# UNITED STATES PATENT AND TRADEMARK OFFICE

| APPLICATION NO.  | FILING DATE | FIRST NAMED INVENTOR | ATTORNEY DOCKET NO. | CONFIRMATION NO. |
|--|-------------|----------------------|---------------------|------------------|
| 10/600,368   | 06/23/2003  | Matthew P. Warden    | ROL-002US           | 7114             |

**Office Action Summary**

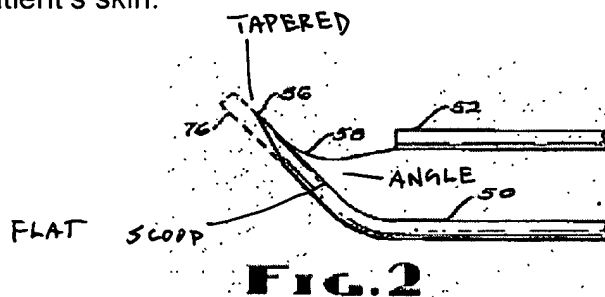
8. Claim 5 is rejected under 35 U.S.C. 102(b) as anticipated by or, in the alternative, under 35 U.S.C. 103(a) as obvious over Babb.

9. Babb teaches the suture removal instrument of claim, wherein the tapered tip comprises a flat scoop. In the alternative, it would have been obvious to one having ordinary skill in the art to make the tapered tip of Babb more flat/shovel like to avoid piercing of a patient's skin.
